JOINT ARCHITECTURAL BOARD/PLAN COMMISSION AGENDA
MONDAY, APRIL 17, 2017
7:00 PM
BOARD ROOM
MUNICIPAL BUILDING, 210 COTTONWOOD AVE.

MEMORANDUM

TO: Architectural Board and Plan Commission
FROM: David E. Cox, Village Administrator 
DATE: April 12, 2017
SUBJECT: Agenda Information – April 17, 2017

NEW STORAGE GARAGE FOR:
LAKE COUNTRY LUTHERAN HIGH SCHOOL

1 ENLARGED SITE PLAN - GARAGE
 AS101 1" = 40'-0"

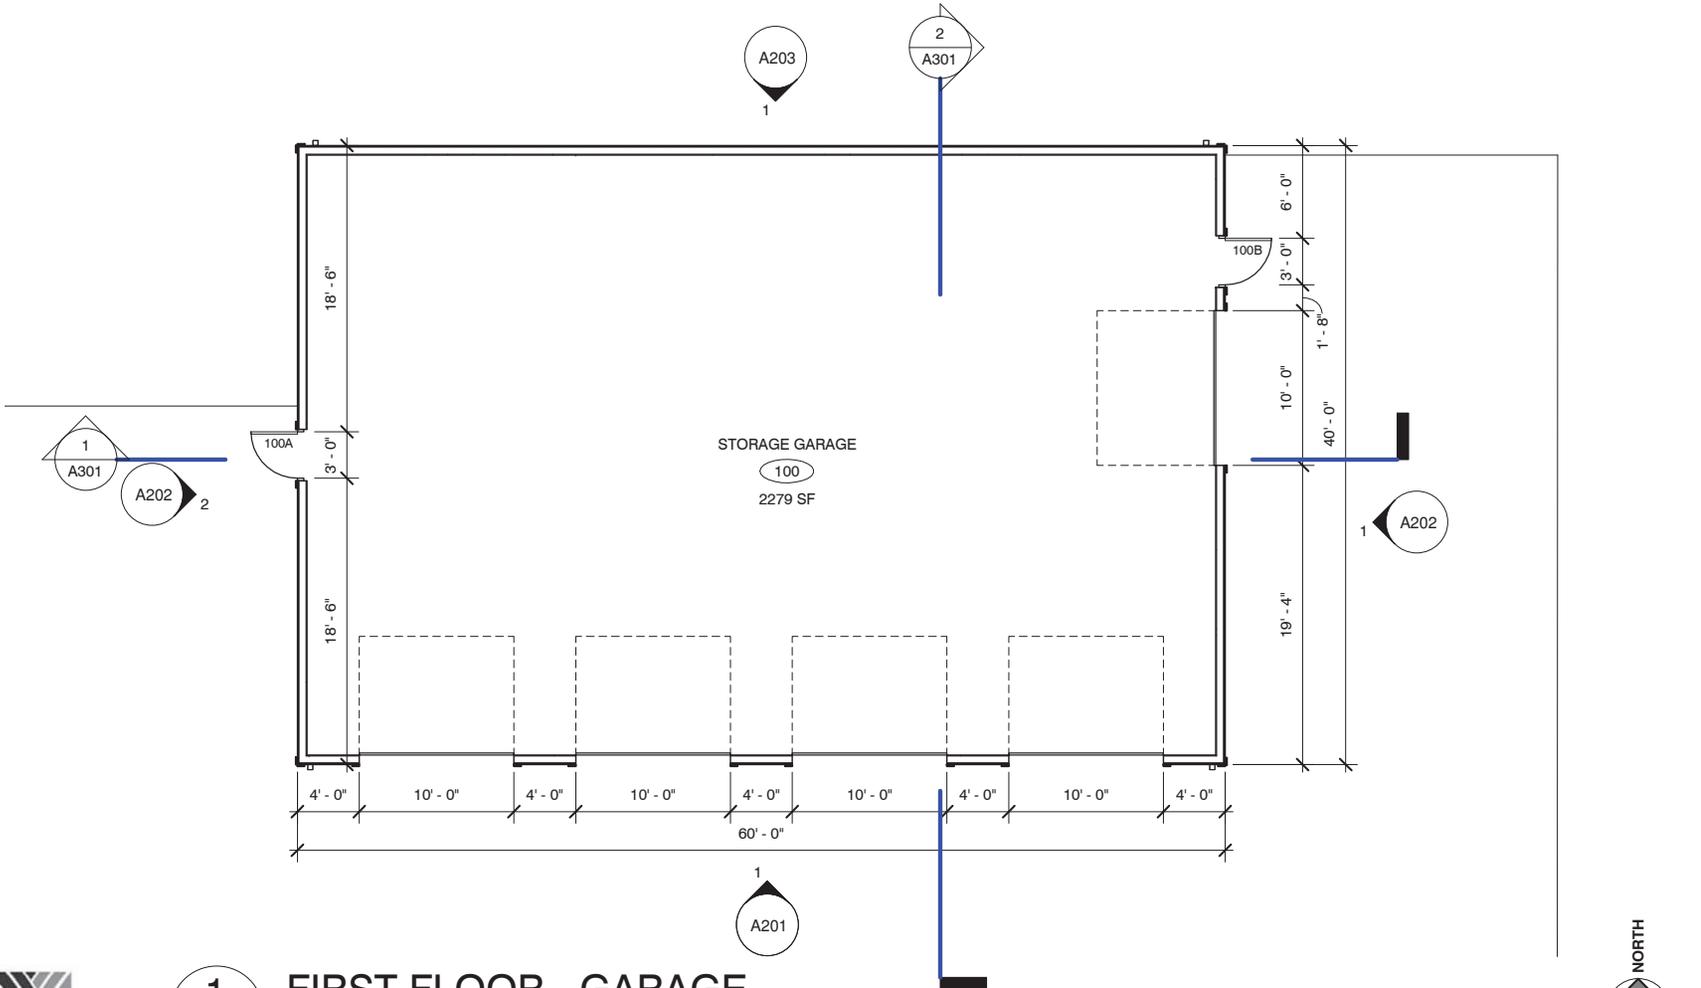
Background: Lake Country Lutheran High School is proposing to construct a 2400 square foot storage garage on an extension of the asphalt for the drive areas north of the school building. The proposed façade for the garage is intended to match the school building as much as possible and includes the construction of architectural features like dormers. The proposal also includes landscape screening of the building from the street, which is about 400 feet or more away. Staff, in general, has no concerns about the proposal. The Architectural Board may wish to consider whether the dormers should be functional (allowing light into the space) or if they could be aesthetic only. Additionally, the Commission may wish to clarify what utilities are planned for the space and for what purposes. Prior to receipt of permits for the project, staff recommends that the applicant be required to provide a clear grading plan and include the intended route for utilities on the site plan.

Recommendation: Recommend approval of the proposed site and building plan for the storage garage.
